CHELAN COUNTY NATURAL RESOURCE DEPARTMENT  
ICICLE CREEK STREAMBANK RESTORATION-RM 1.0

**ADDENDUM NO. 2**

**1. Revised Final Plans Set with Corrections to LWM Structure Log Schedule's**

CHECKED BY: SRSE  
 DESIGNED BY: DNH  
 DRAWN BY: DNH  
 FIRST SUBMITTAL DATE: 1/14/22  
 PROJECT NO. **CHEC00000020**  
 SHEET NO. **12** OF **18**  
**DT05**

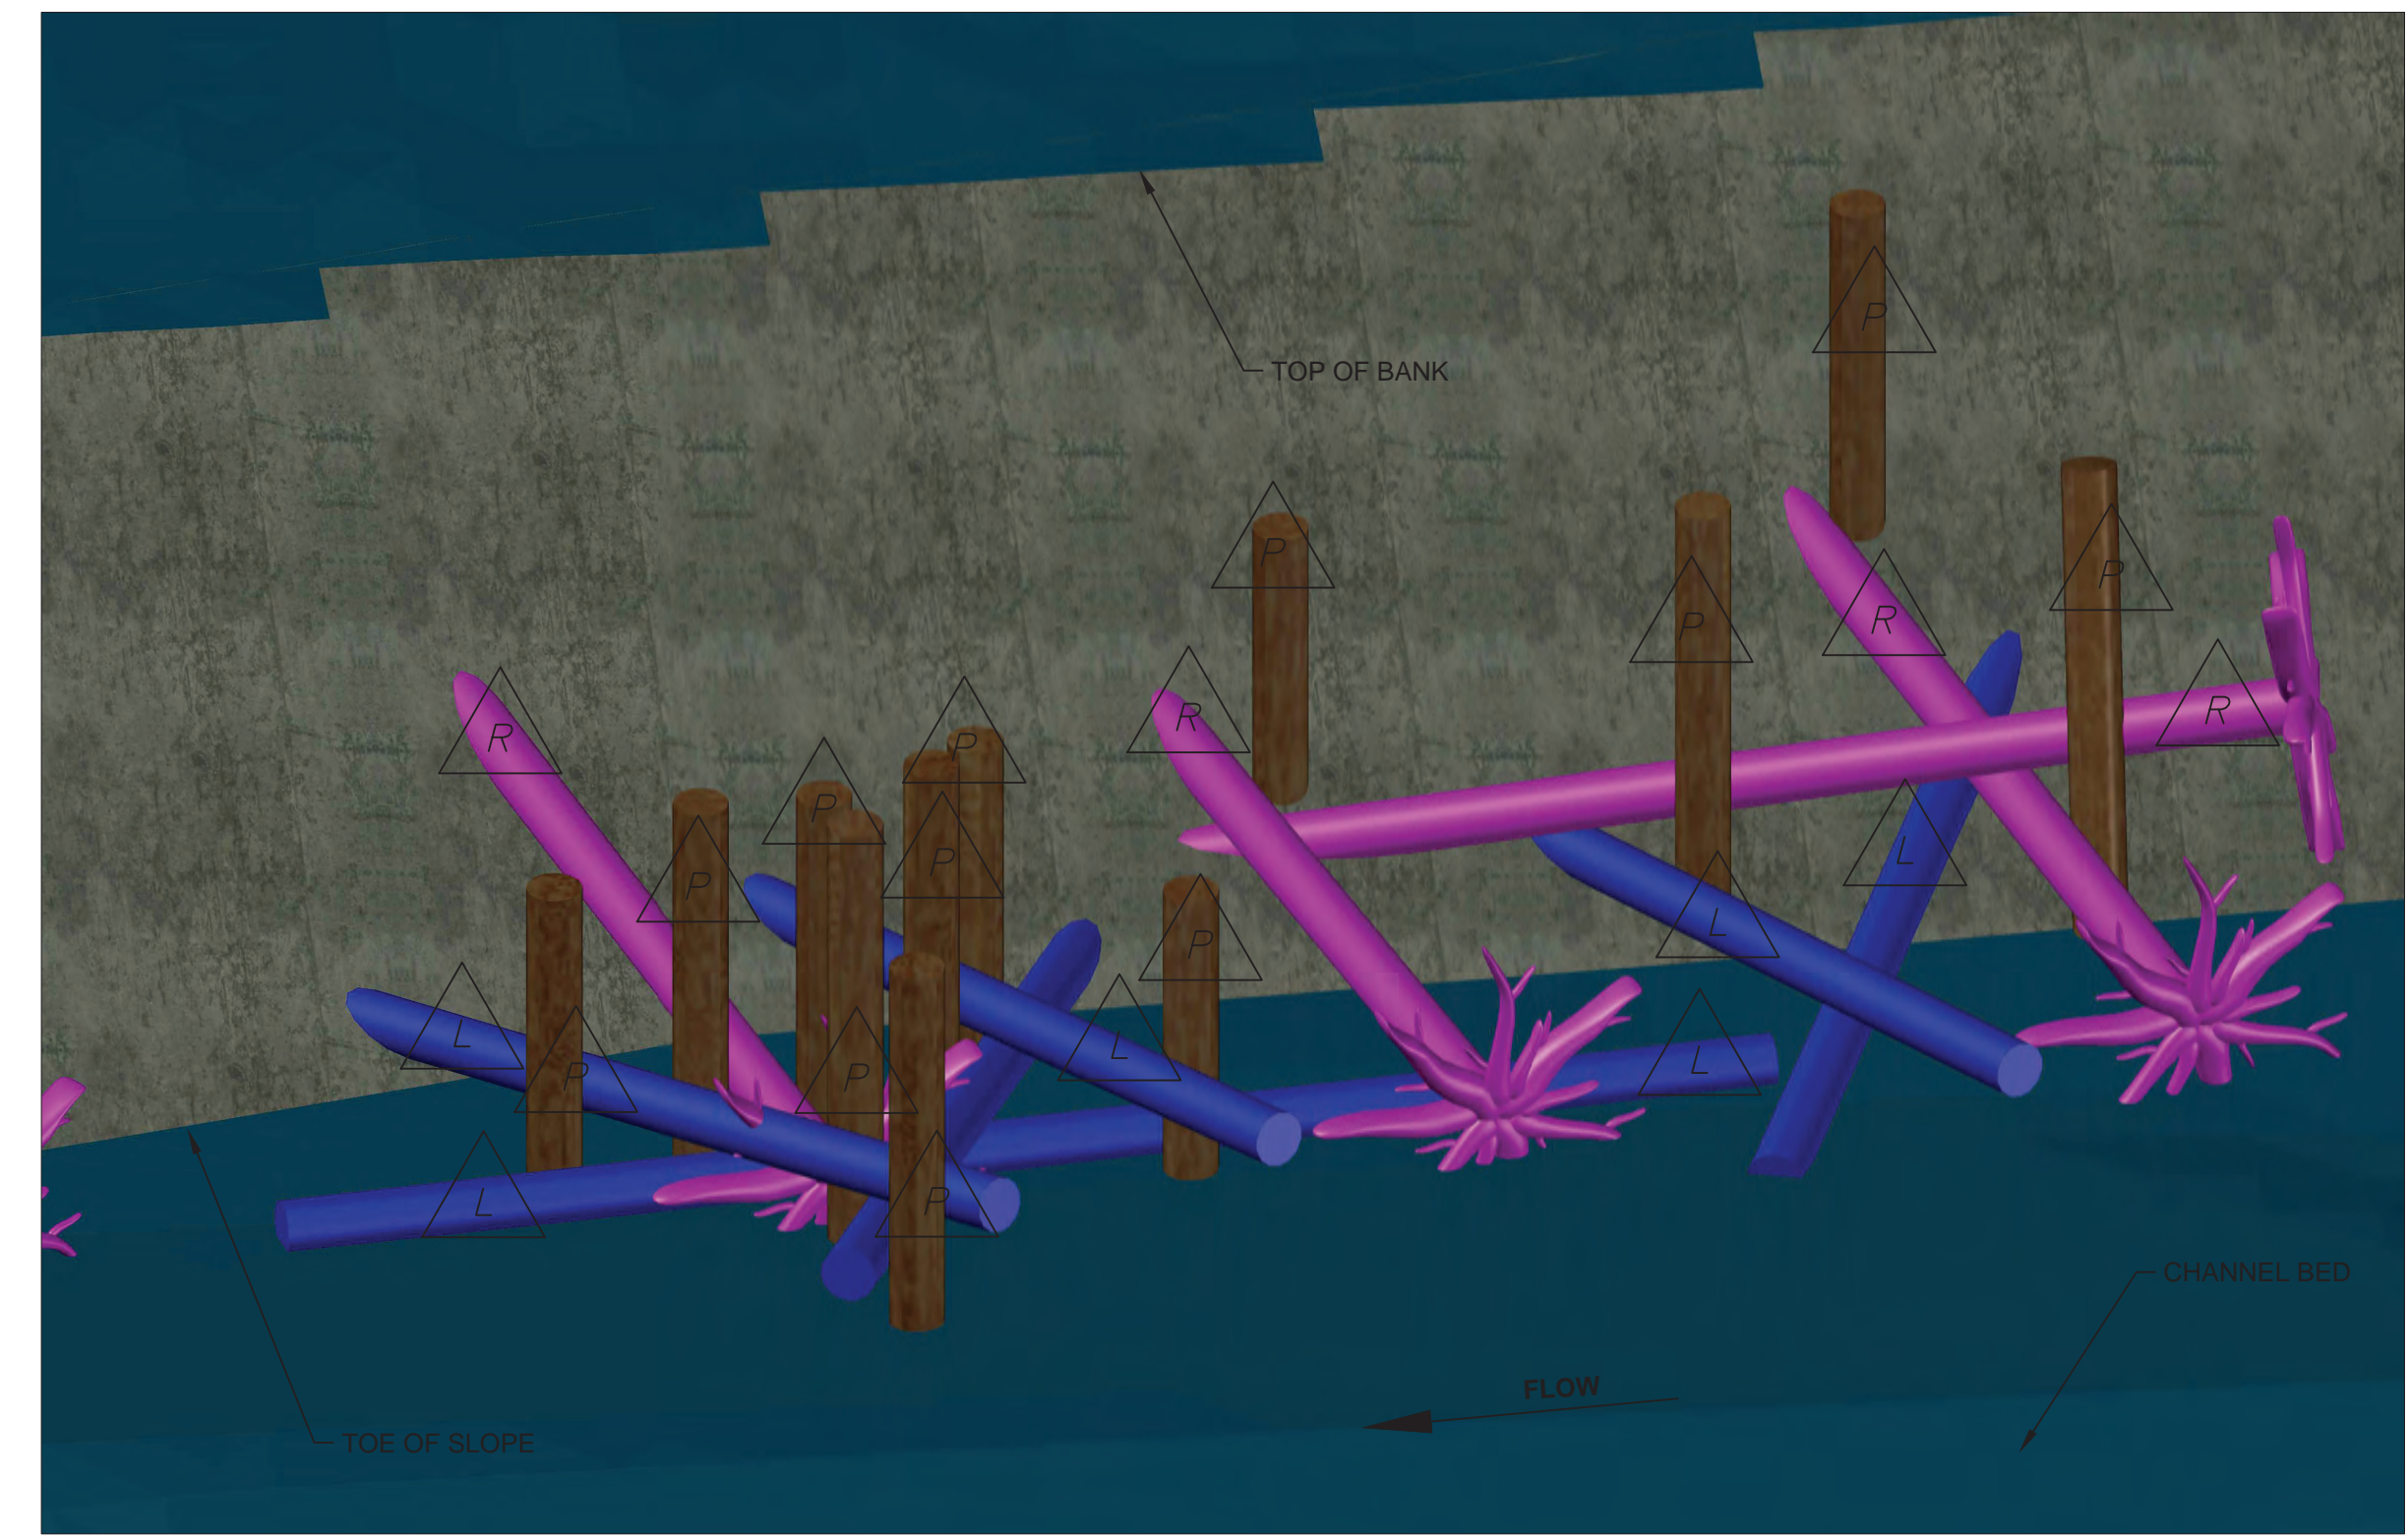
The "LWM Structure Log Schedule" on both sheets 9 (Type 1 LWM Structure) and 12 (Type 2 LWM Structure) have been corrected to show a pile length of 25' and dbh of 12"-15" as indicated in section 8-26.2(1) of the special provisions. The updated plans provided with this addendum are considered the new Final Plan set for this project.

DATE: 3/4/22	BY: OK
REVIEWED BY: S. SEVILLE	SS
NO. DATE REVISION	
1 3/4/22 corrected pile log diameter and length

LWM STRUCTURE LOG SCHEDULE						
LOG ID	COLOR	DIA. (INCHES)	LENGTH (FEET)	ROOTWAD (Y/N)	QUANTITIES PER STRUCTURE	NOTES
R		18	40	Y	4	
P		18- 12 to 15	40 25	N	12	
L		18	40	N	6
